December 31, 1982
ST-HL-AE-919
File No: G9.15

South Texas Project
Units 1 & 2
Docket Nos. STN 50-498, STN 50-499
Responses to NRC Review Questions

RESPONSES TO NRC QUESTIONS
220.06, 220.08, 220.09,
230.01, 230.04, 231.02 and 231.03

Figure 1

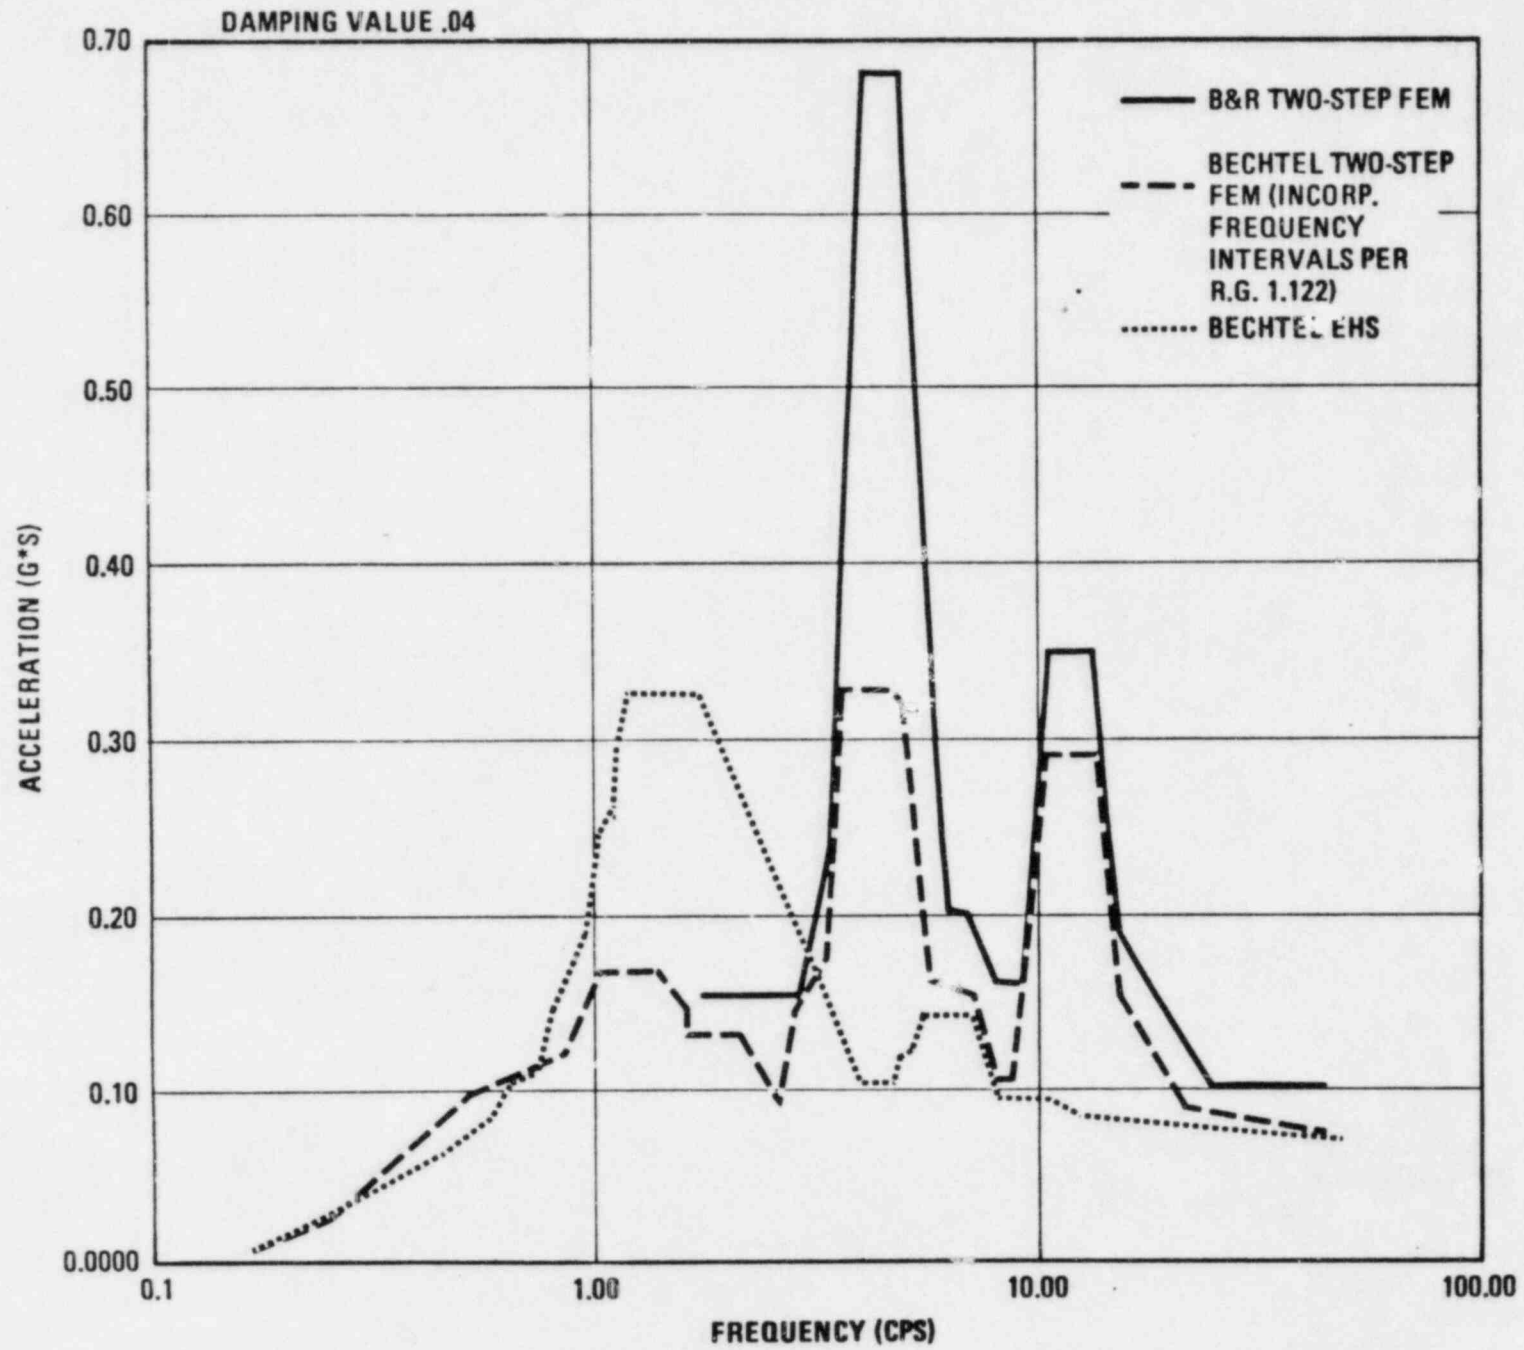
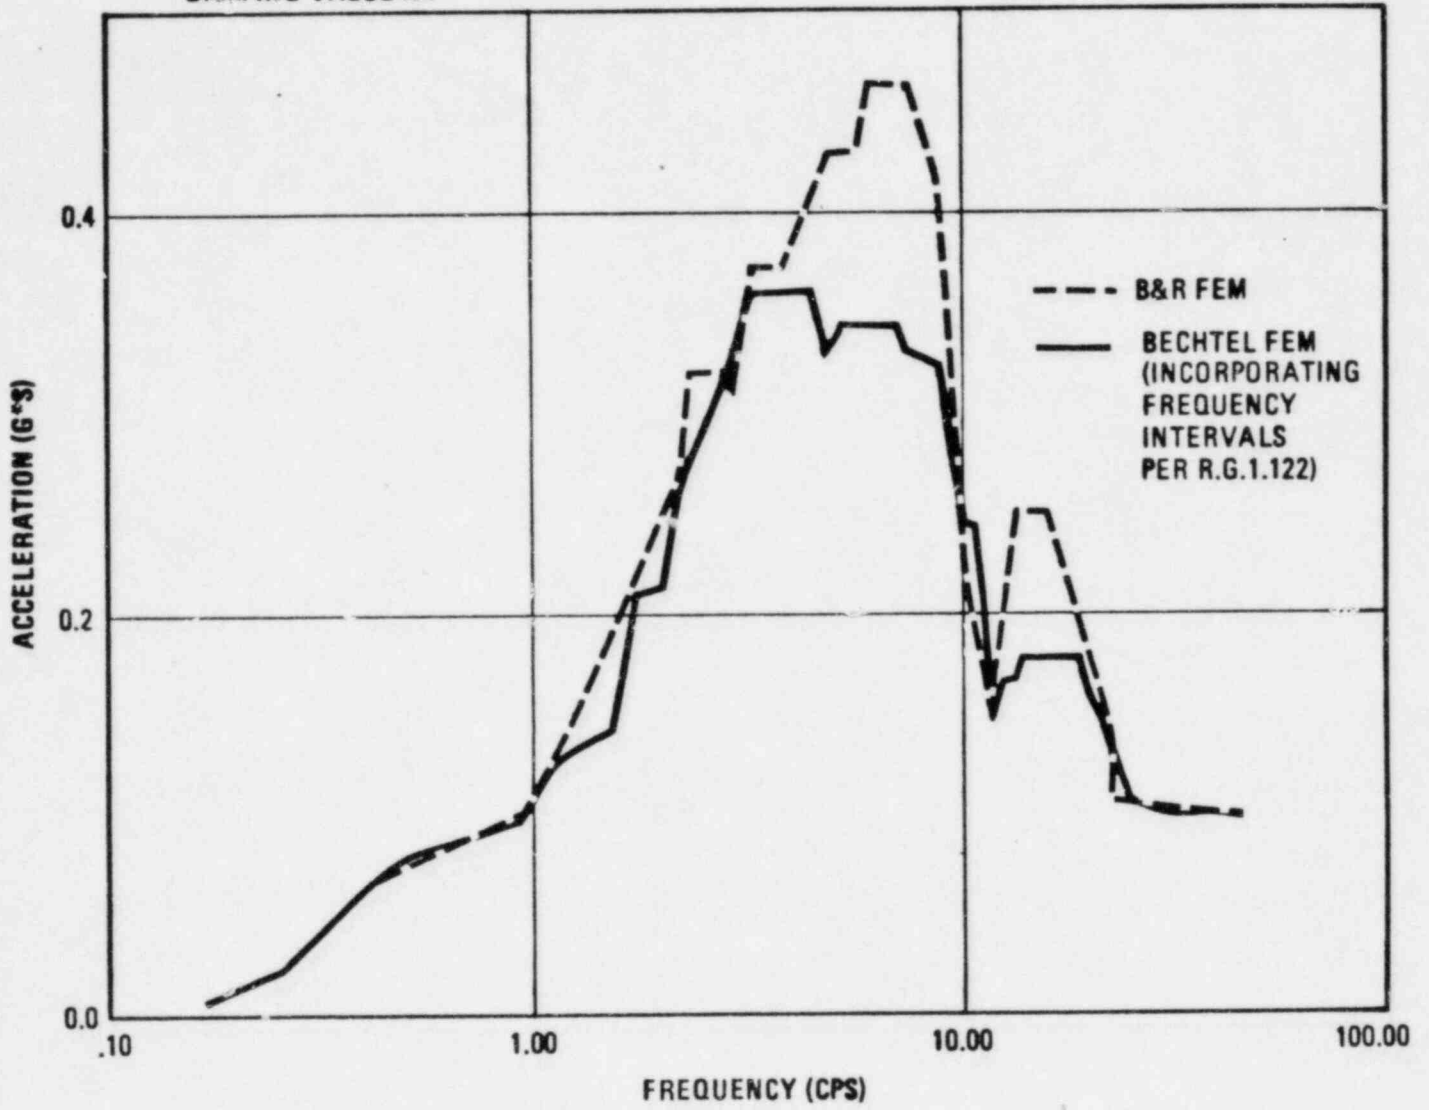
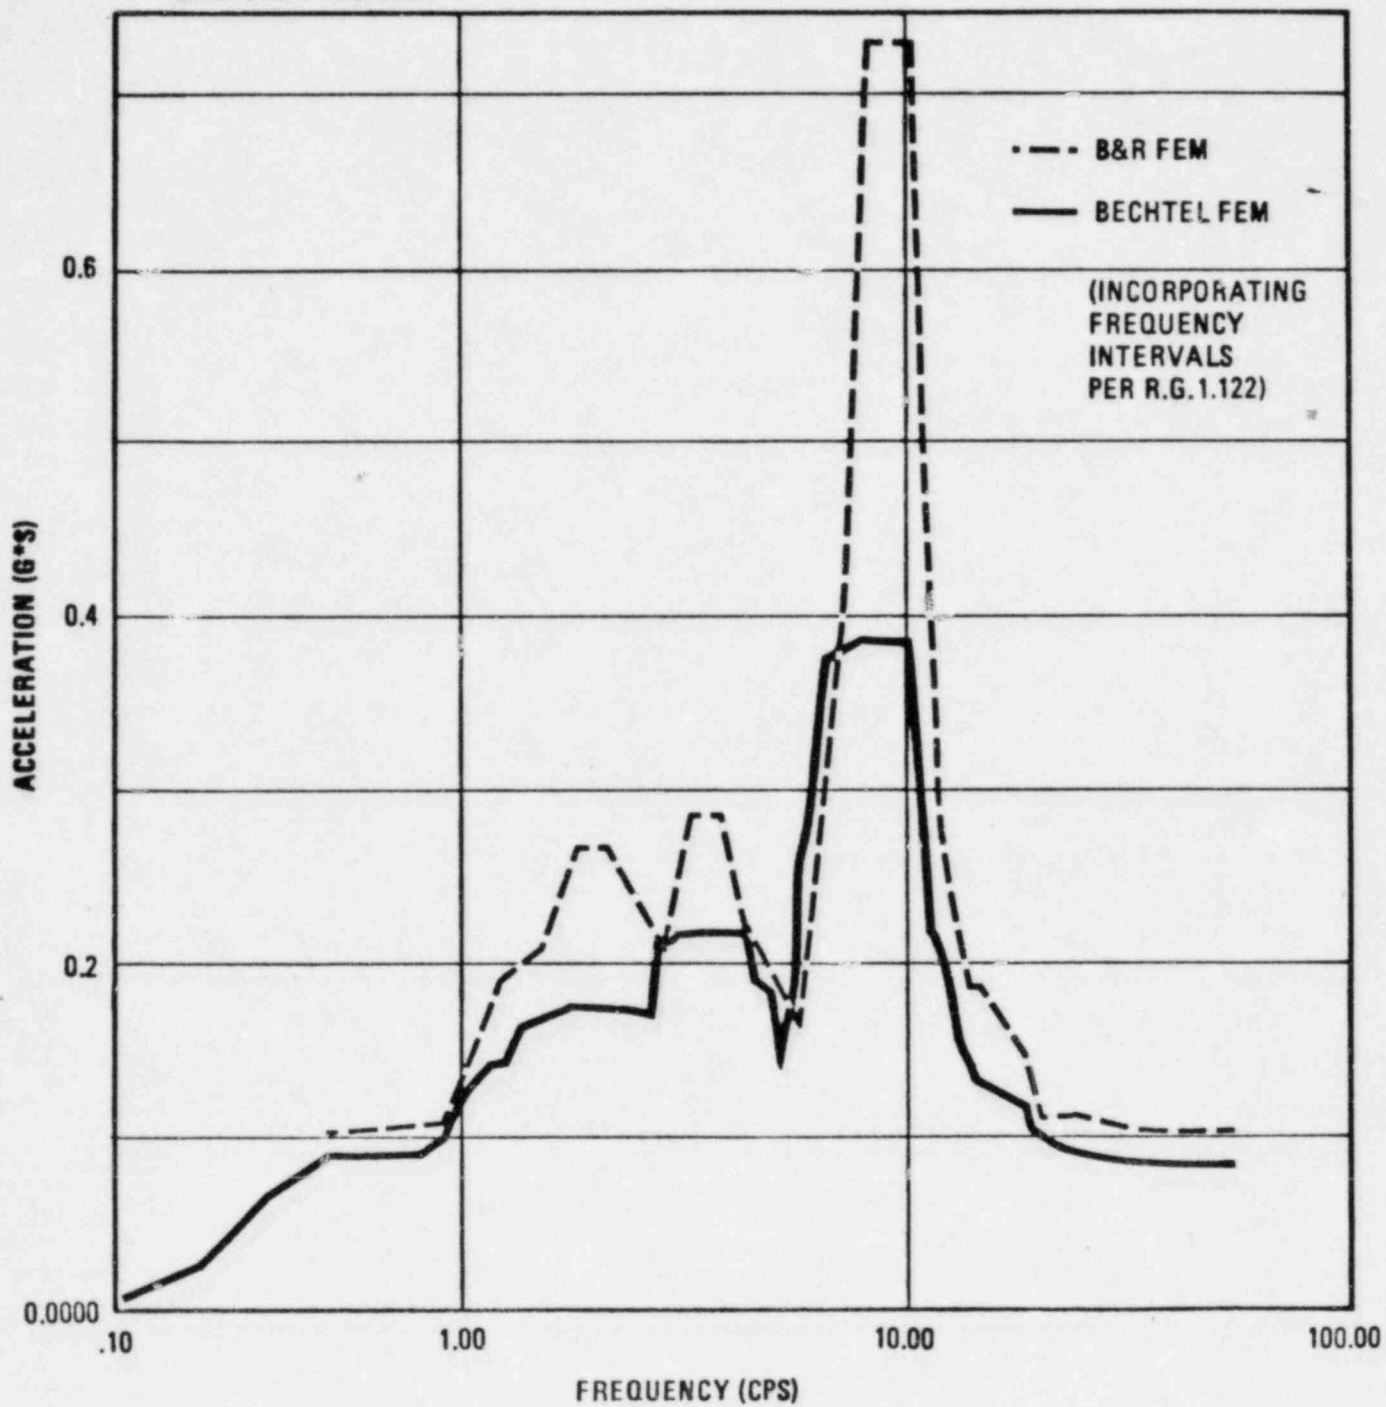
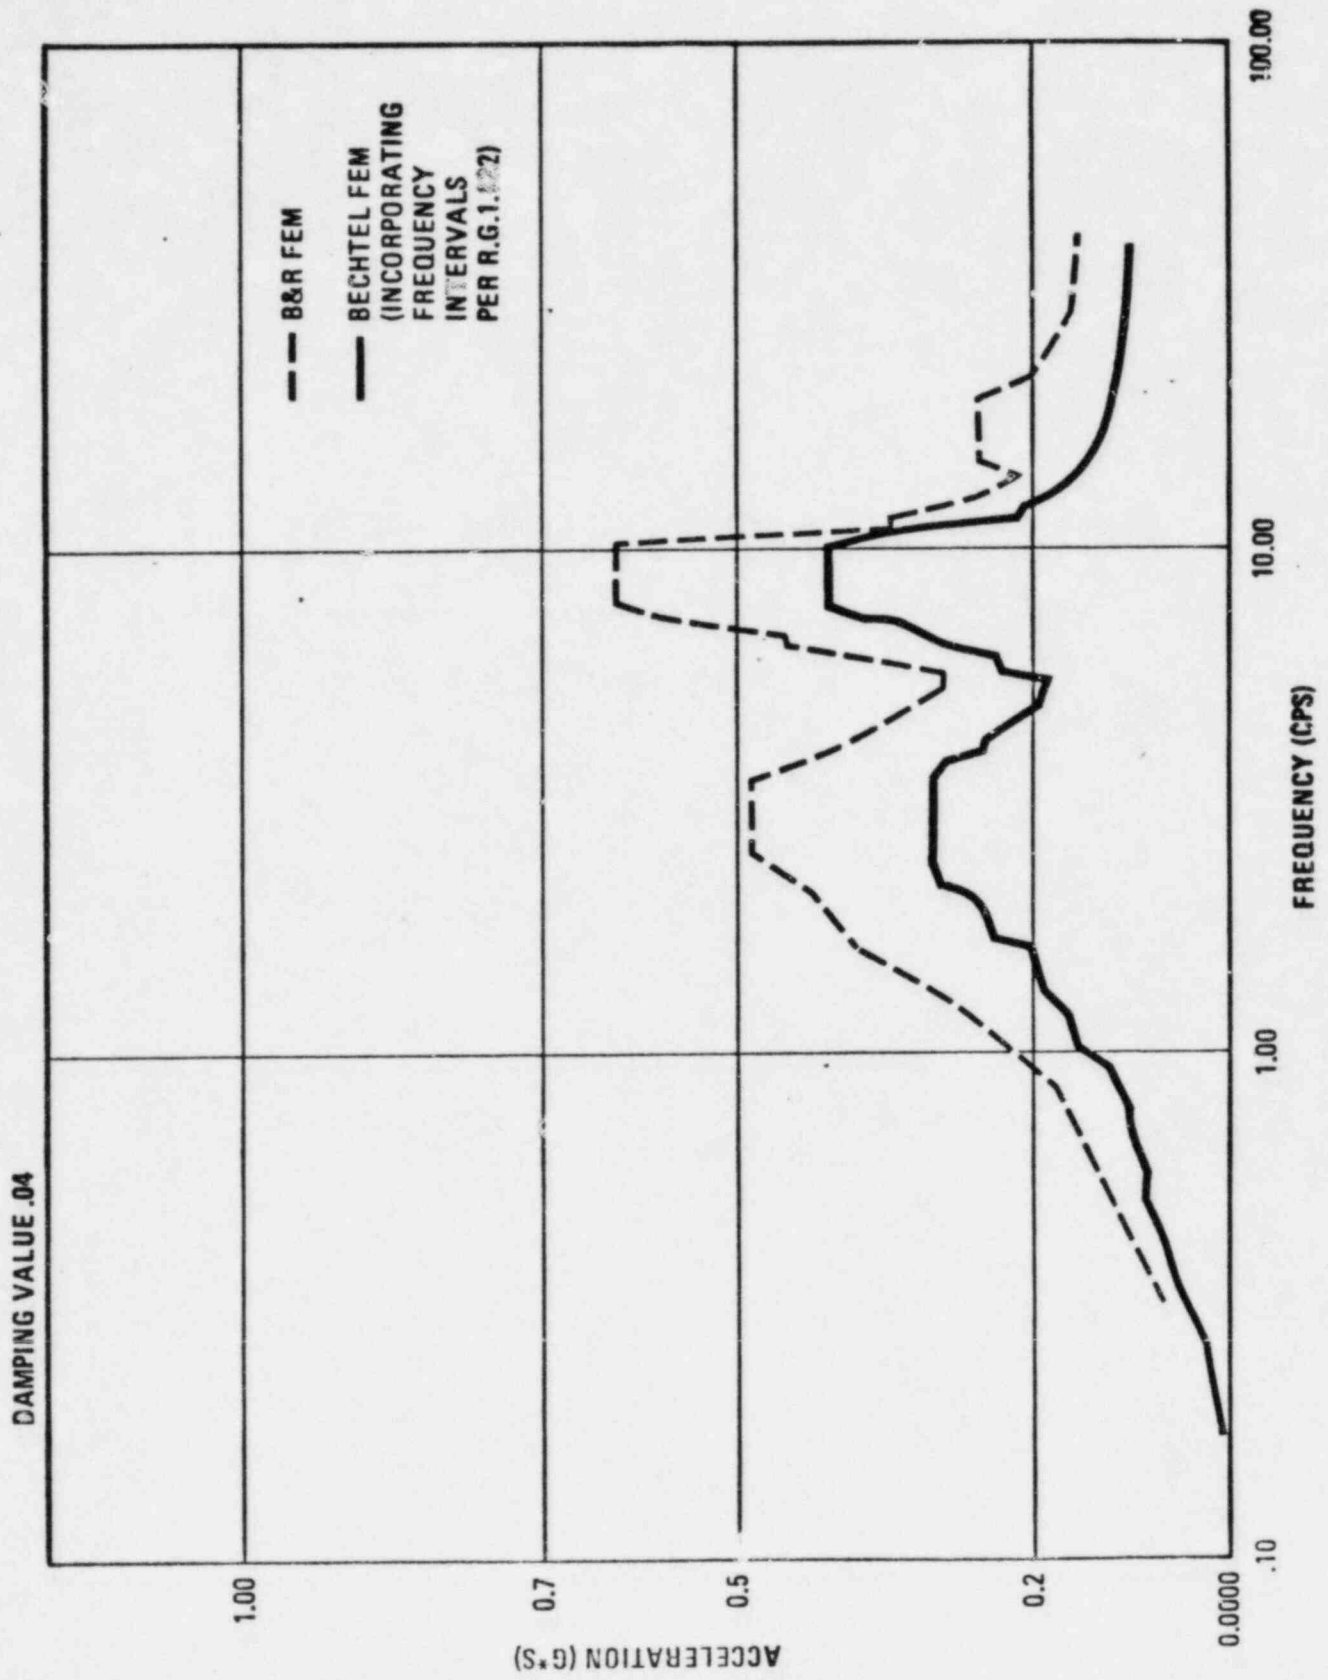
Confirm that the frequency intervals used for floor spectra generation are small enough that their reduction does not result in more than 10 percent change in the computed spectral values.

Response spectra calculations parallel to the original B&R calculations, incorporating the prescribed frequency intervals per Regulatory Guide 1.122 and other minor modifications, were performed in order to resolve the frequency-interval concern and to evaluate the original seismic dynamic analyses. The results indicate that the only significant difference associated with the frequency interval pertains to the sparseness of the intervals used for the spectral response calculation detected at frequencies below 2.5cps and only for the Reactor Containment Building. For the higher frequency range, the frequency intervals used are adequate and the original response spectra is conservative; refer to Figure 1 through 4. For a comparison of the frequency intervals per R.G. 1.122 with those used in the original calculation refer to Table I. From the tabulation the sparseness of the original frequency intervals is evident.

The distinctly higher peaks of the B&R solution compared to the Bechtel solution are attributed to (1) the method used by B&R to combine response spectra along parallel directions due to orthogonal input, and (2) slight variations in the structural model configurations. However, for response spectra comparisons, the fact that there are no frequency shifts and similar high-frequency range and zero-period accelerations are preserved is a more meaningful basis for comparison than on the basis of similitude of peak values.

The sparseness of the frequency intervals of the original calculations diminished the resolution of the spectral calculation and contributed to the under-representation of spectral response in the low frequency range identified in Response 220.08 pertaining to the EHS method for SSI. The spectral response calculated using the R.G. 1.122 frequency intervals exceeds slightly the original spectra and extends the range of resolution into the low frequency range. The resultant spectra however, is consistently enveloped by the EHS spectra addressed in the cited response; refer to Figure 1. Therefore the frequency-interval implications on the spectral response are analogous and bounded by the EHS implications and are similarly dispositioned.
